**Re: The following pages are pertaining to:  
Recall 06V450000 - US Units  
Recall 06-318 – Canada Units**

**Recall Campaign 06V450000 US Units**

**Re: Safety Recall – Windshield Wiper Circuit**

**RECALL 06V450000**  
**CANADA # 06-318**  
**WINDSHIELD WIPER FUSE UPGRADE**

figure 1

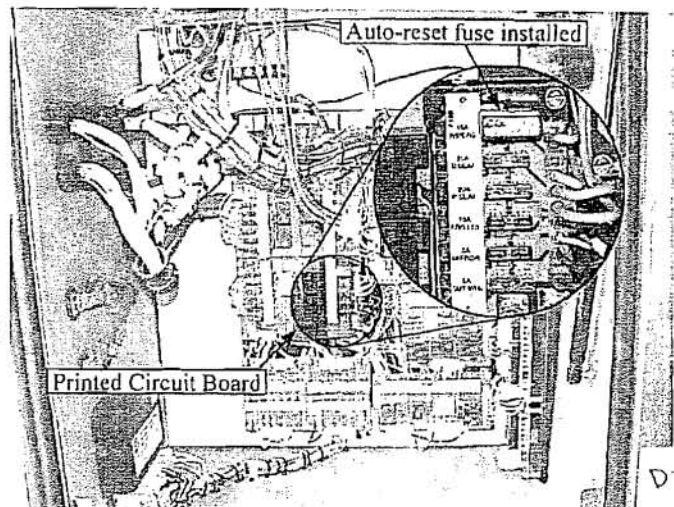
Under certain driving conditions, specifically when the windshield is drying off, the increased resistance on the wiper motor may cause the 15 AMP fuse to fail resulting in the loss of windshield wiper function. As a result the installation of a 15 AMP auto-reset fuse in place of the standard 15 AMP fuse will be necessary.

1. Locate front electrical run panel in front of the driver side front tire
2. Locate the 15 AMP windshield wiper fuse on the printed circuit board (figure 1).
3. Replace the standard 15 AMP blade style fuse with the 15 AMP auto-reset fuse.

**Kit contains:** 1- 15 AMP auto-reset fuse.
